REVISED
5-18-92

No. 92-9

A. ENGINE ALIGNMENT TOOL MODIFICATION

Figure 1.

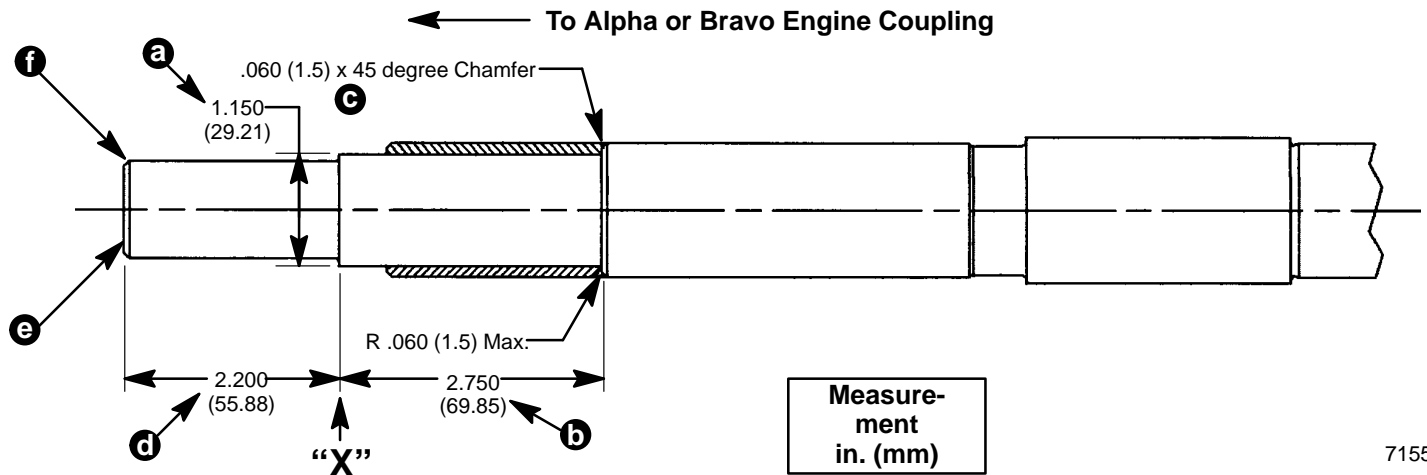
An engine coupler change will take place on these model engines sometime in August, 1992. Because of this change, the current Alignment Tool (91-57797A3) will not properly align the engine. Please have your current alignment tool modified as shown in Figure 1 or order a new alignment tool.

Use the first step on the tool as reference point "X".

- 1) The shaded area of the tool must be machined off. Machine the 1.150 in. (29.21mm) diameter (a) back for a total of 2.750 in. (69.85mm) (b) from reference point "X". Finish the edge of the new step as shown by (c).
- 2) Measure from reference point "X" to the end of the tool. This should not be longer than 2.200 in. (55.88mm) (d). If the step is longer, remove material from the end (e) until the step is 2.200 in. long. If material was removed, put a .060 in. (1.5mm) x 45 degree chamfer on edge (f).
